REPORT TO: Committee of Adjustment

REPORT NO.: DSD-2025-277

SUBJECT: Minor Variance Application A2025-057 - 386 Wake Robin Cres.

Figure 3: South Elevation (Front) proposed via Subject Application A2025-057.

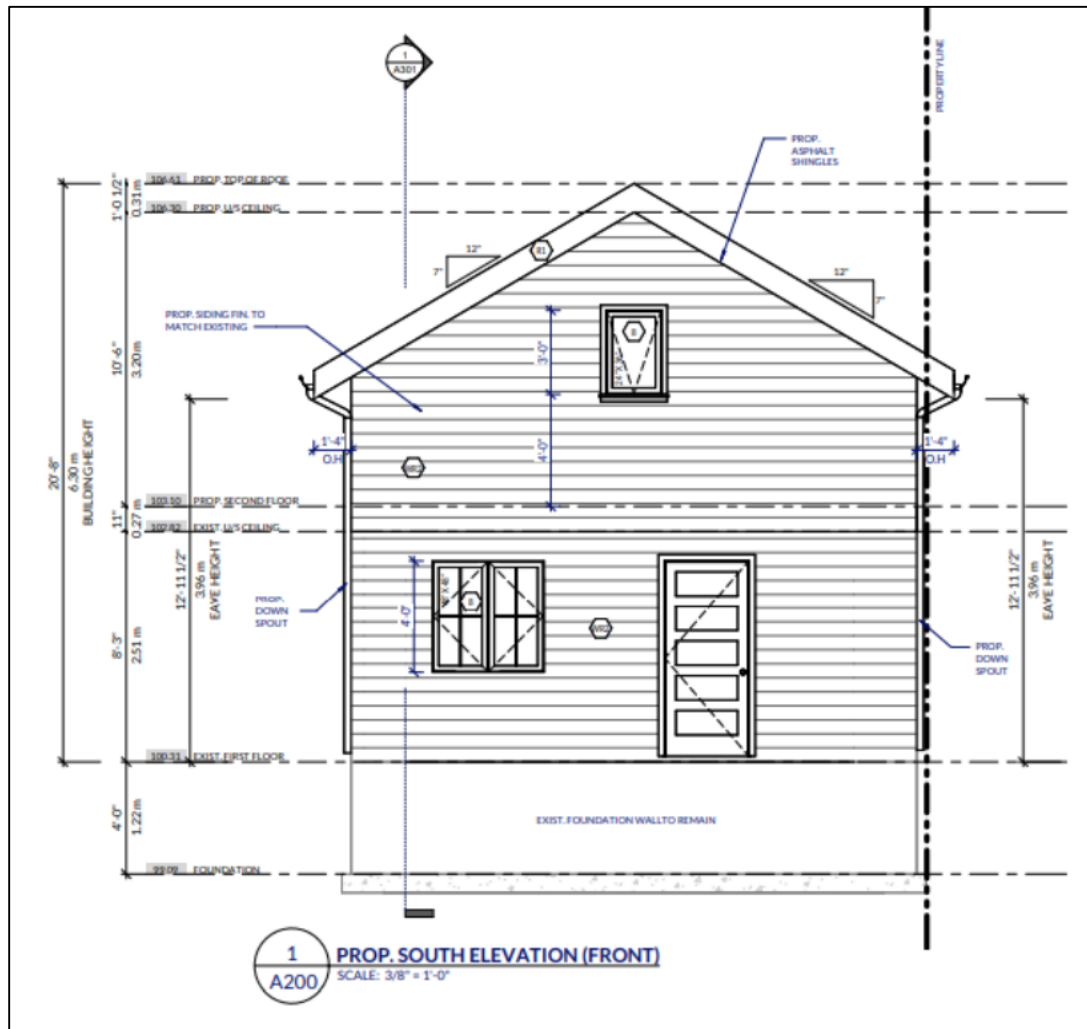
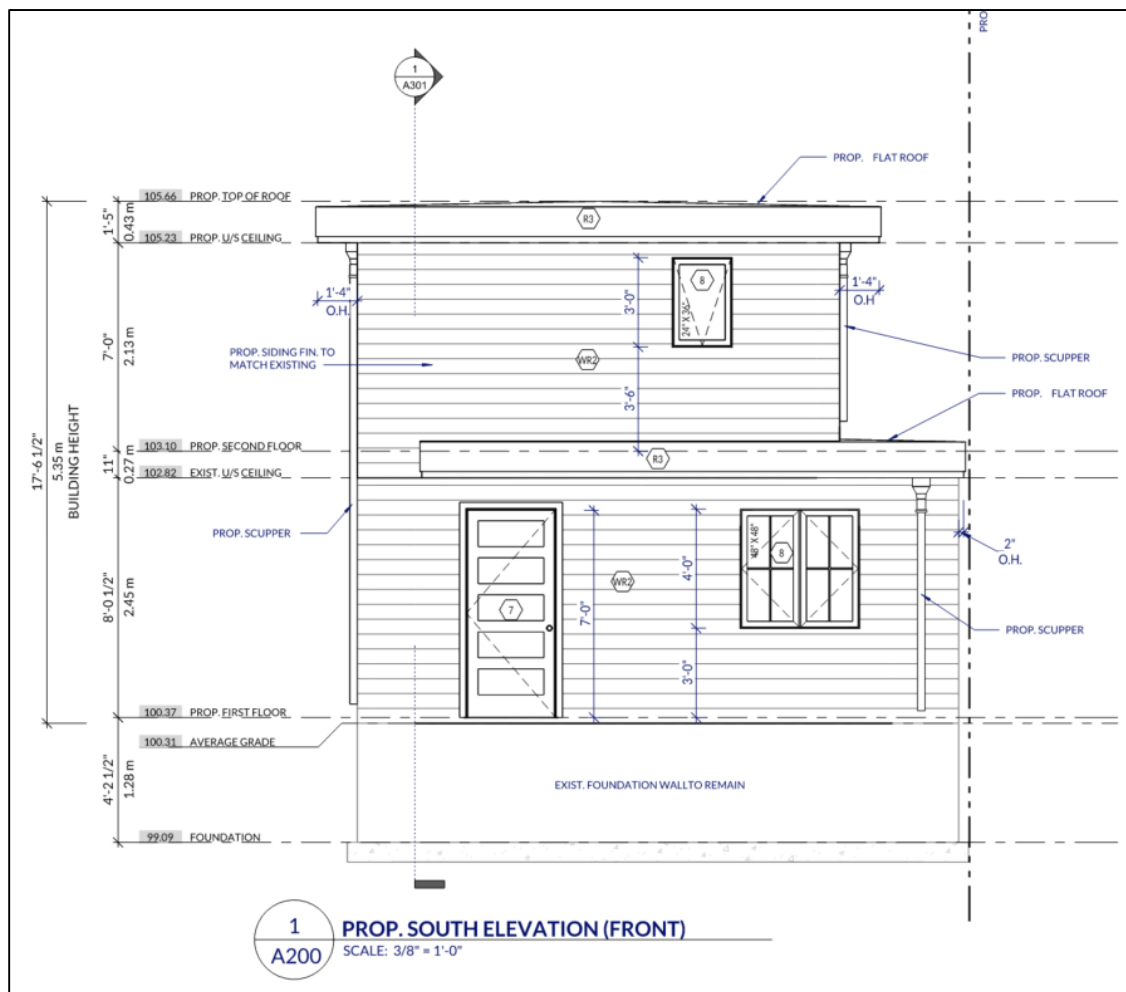
It should be noted that the design of the second storey addition to the accessory structure proposed via A2024-090 is noticeably different than the second storey addition proposed via the subject application to convert the accessory structure (detached garage) to an Additional Dwelling Unit (Detached), as shown in Figures 2 and 3, below.

Scale: 3/8" = 1'-0"
EXIST. & PROP.
SOUTH
ELEVATIONS

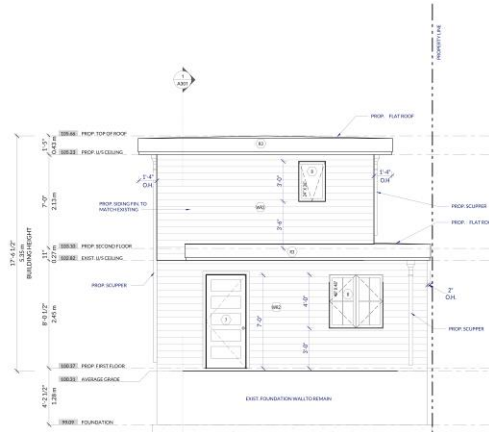
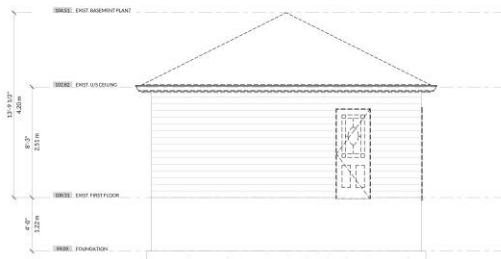
The proposed ADU (Detached) has a flat roof design. ADUs with other roof styles / shapes (i.e., hip, gable, shed, or gambrel roof, mansard) have a markedly higher minimum building height (i.e., 4.5 metres vs 3 metres). The reason is that a flat roof maximizes building bulk (and, therefore, potential impacts), whereas other roof styles / shapes have reduced building bulk to varying degrees. Also, the minimum setback regulation applies to ADUs (Detached) which exceed a building height of 4.5 metres. In this case, the ADU (Detached) is proposed to have a height of 5.4 metres. However, it should be noted that the existing detached garage is currently set back 0.1 metres. As part of the conversion of the garage to an ADU (Detached), a second storey would be added. This second storey would be set back approximately 1.3 metres from the side lot line. Accordingly, the side yard variance is only required to *legalize* the existing setback, and is not required for the proposed second storey. And, while a flat roof is proposed, massing / bulk directly adjacent to the side yard is mitigated because of the increased second storey setback.
